**ESENCIA K-8 PORTABLES PHASE 2 PROJECT
Bid No. 2324-09**

**ADDENDUM NO. 2
May 6, 2024**

Subject: **ESENCIA K-8 SCHOOL
MODULAR CLASSROOMS**
Capistrano Unified School District

ADDENDUM No. 2

FIRE ALARM OVERALL SITE PLAN

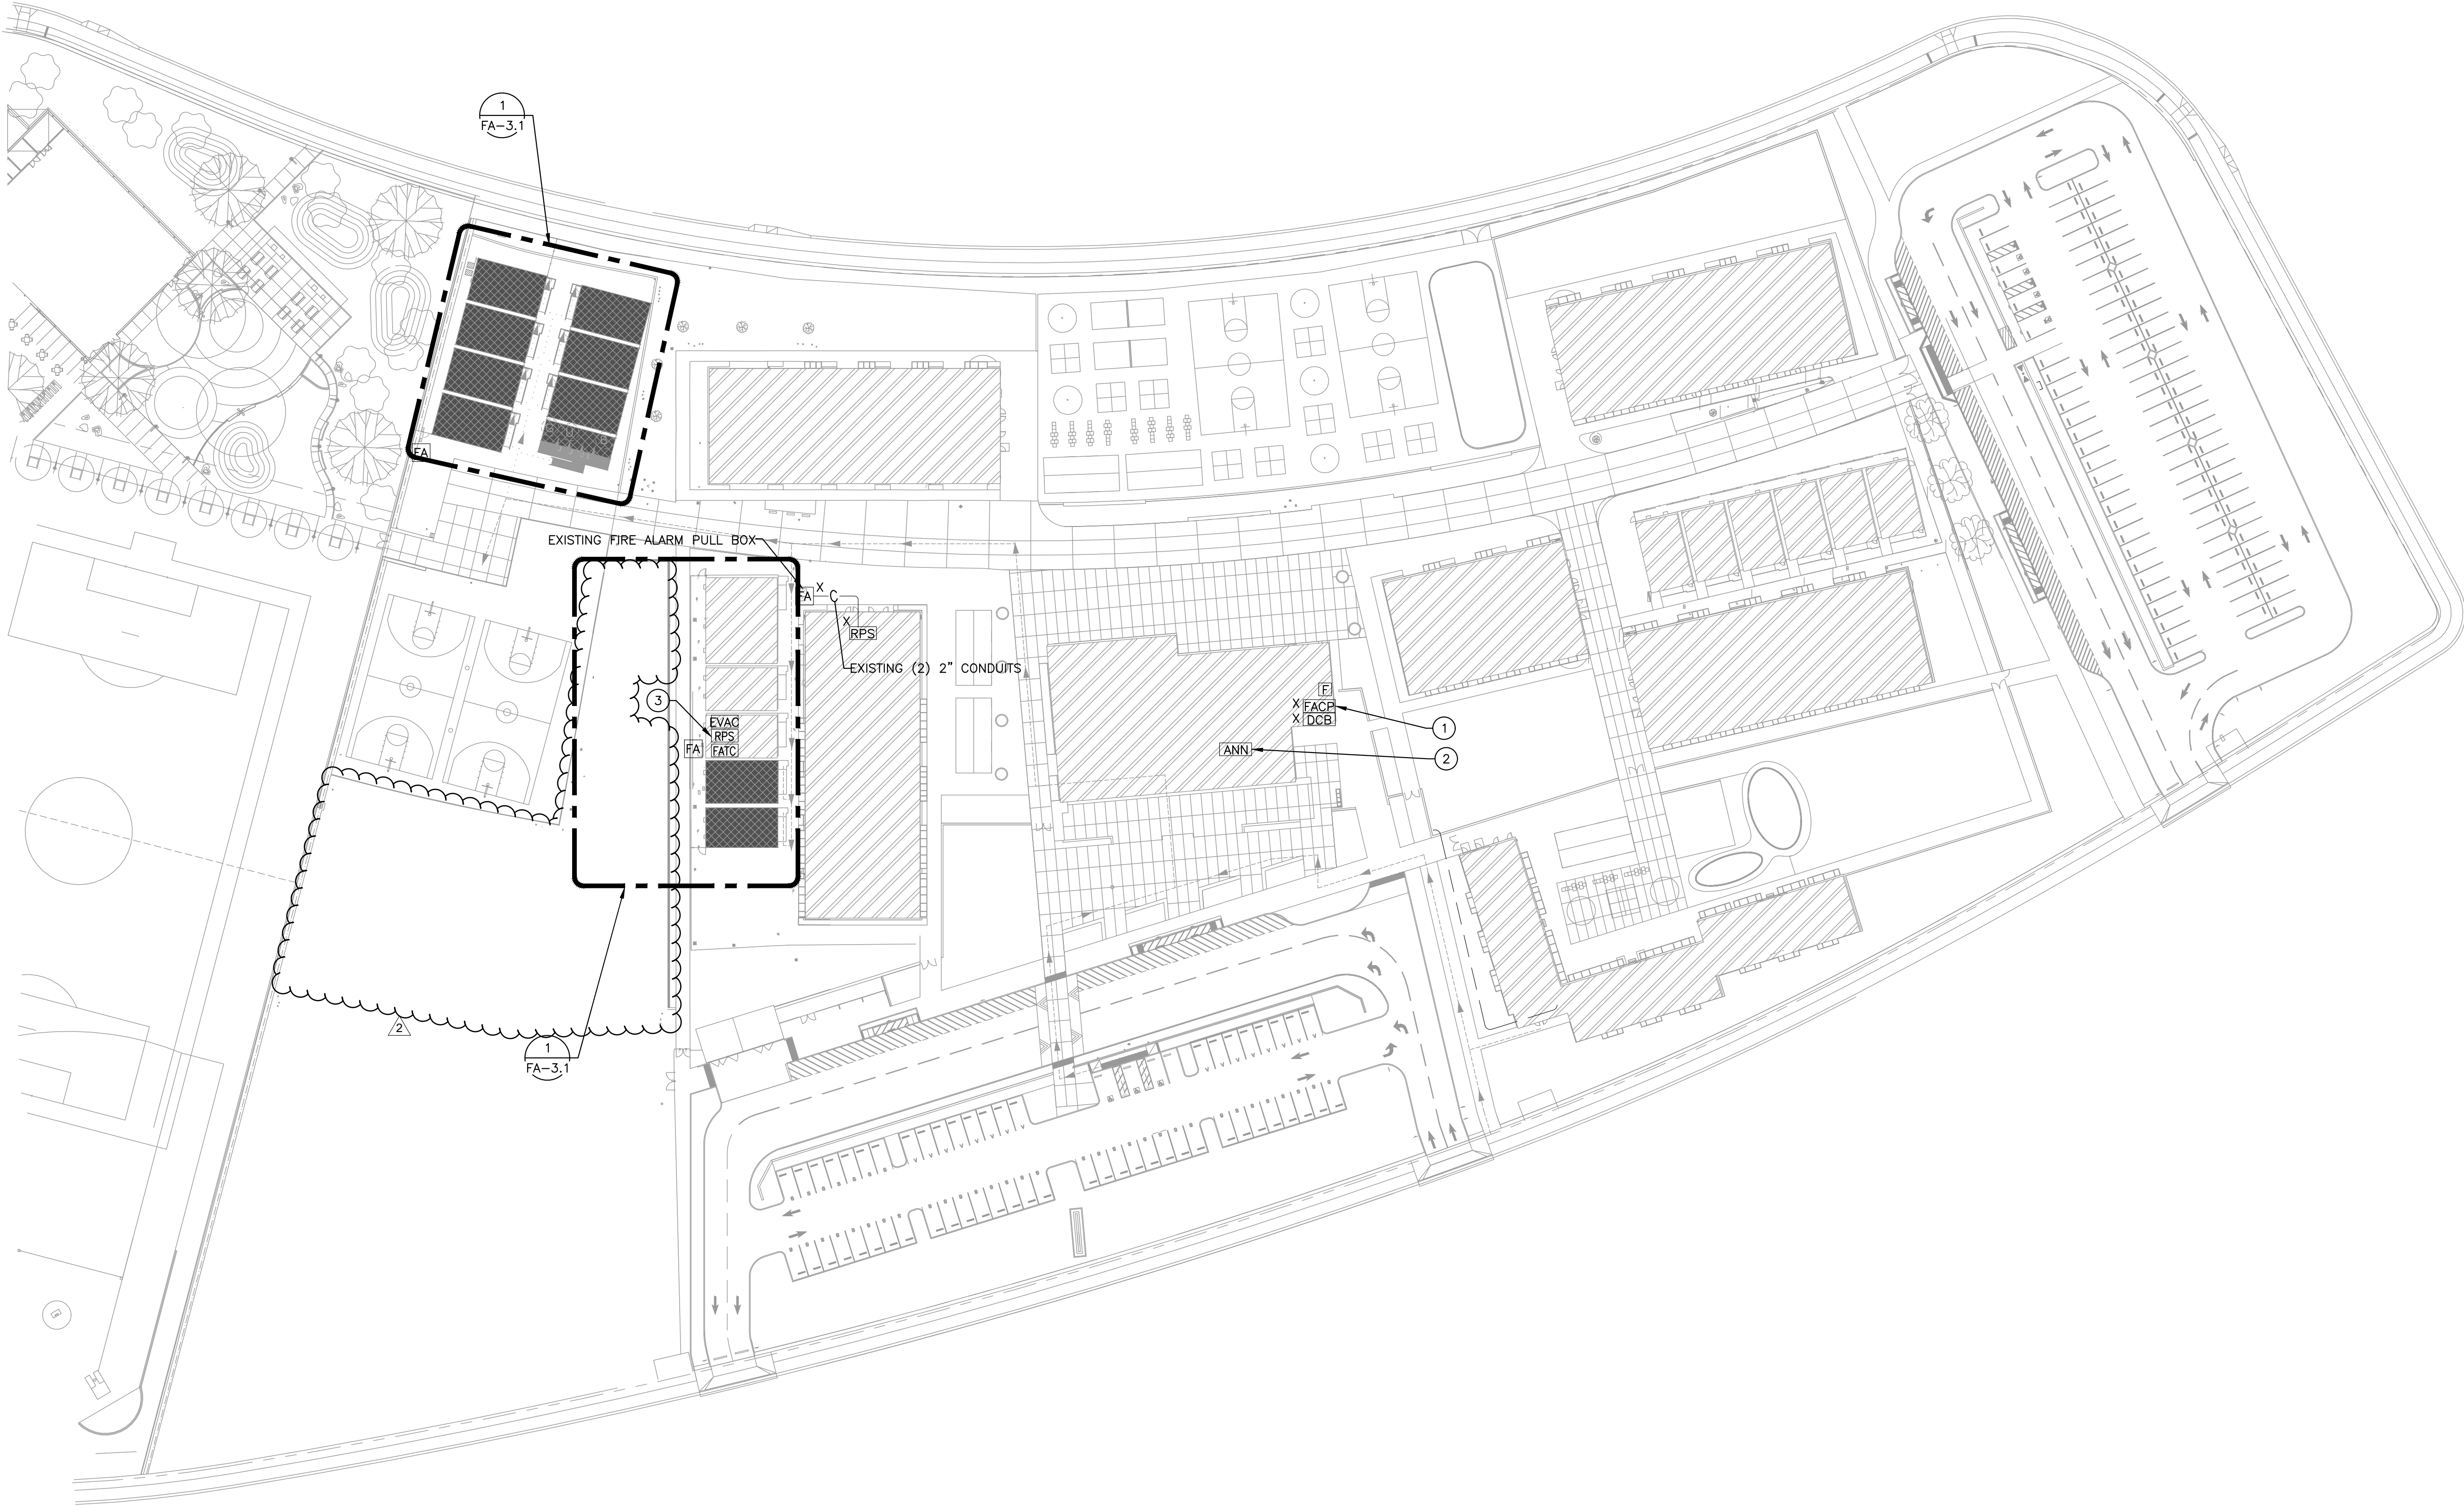
- A. At Fire Alarm Overall Site Plan, delete future portable buildings (shown dashed) and two (2) basketball courts shown east of new exterior light fixtures at existing basketball courts.

A1.0Aa-M

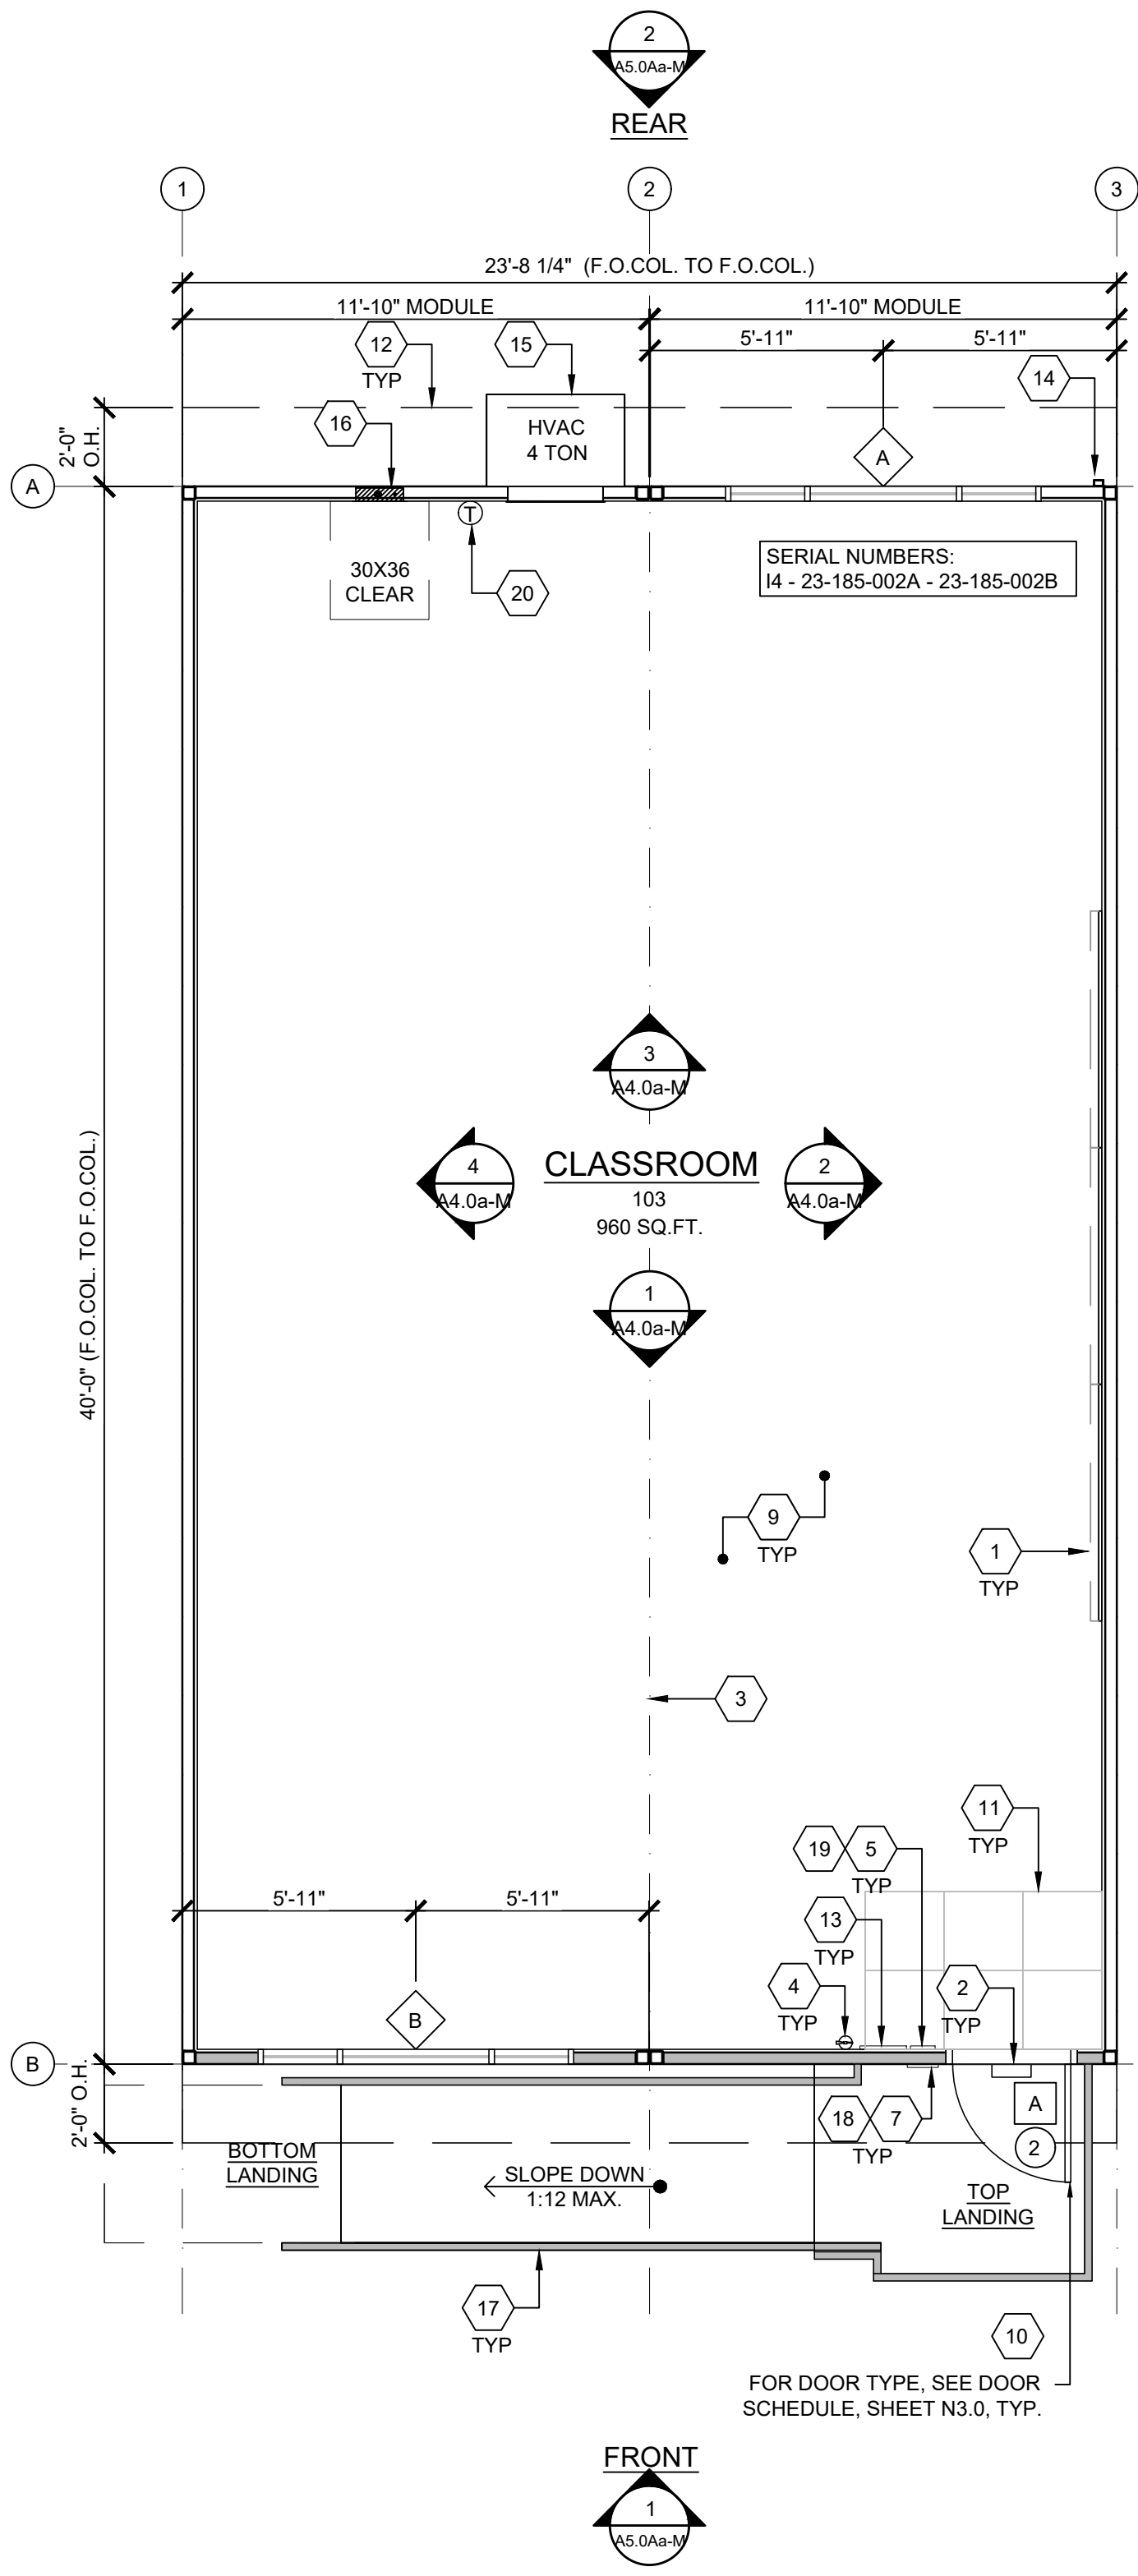
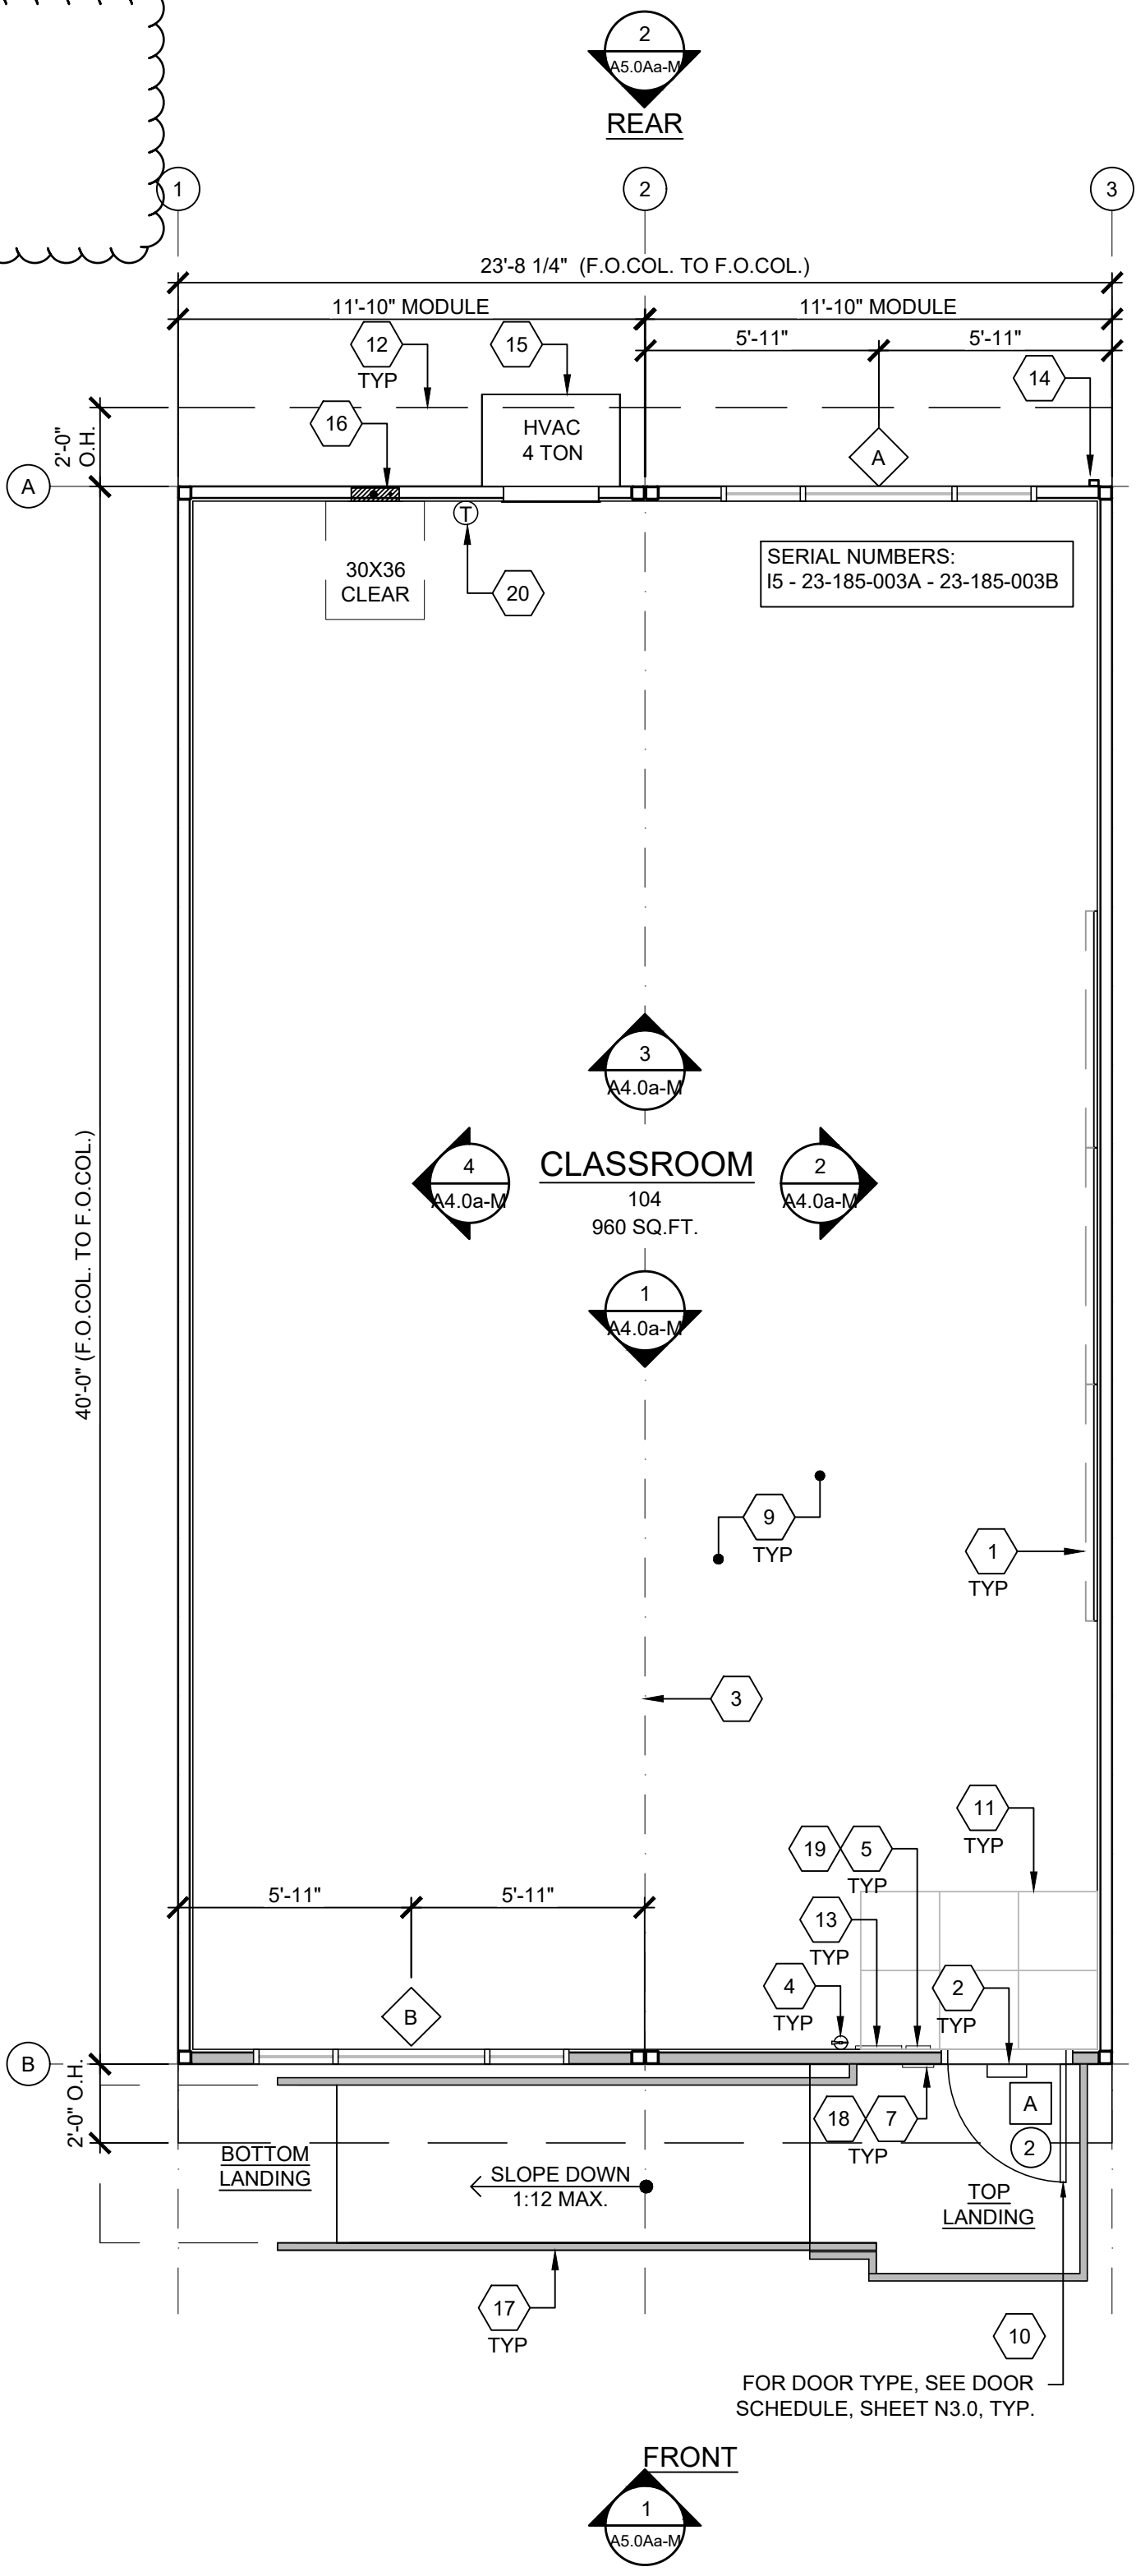
- A. At detail D Typical Floor Plan – Building '15", delete note at upper left corner regarding locations of fire rated construction (note that fire rated construction is already shown through wall types per Wall Legend, and per Door Schedule and Window Schedule on sheet N3.0a-M).
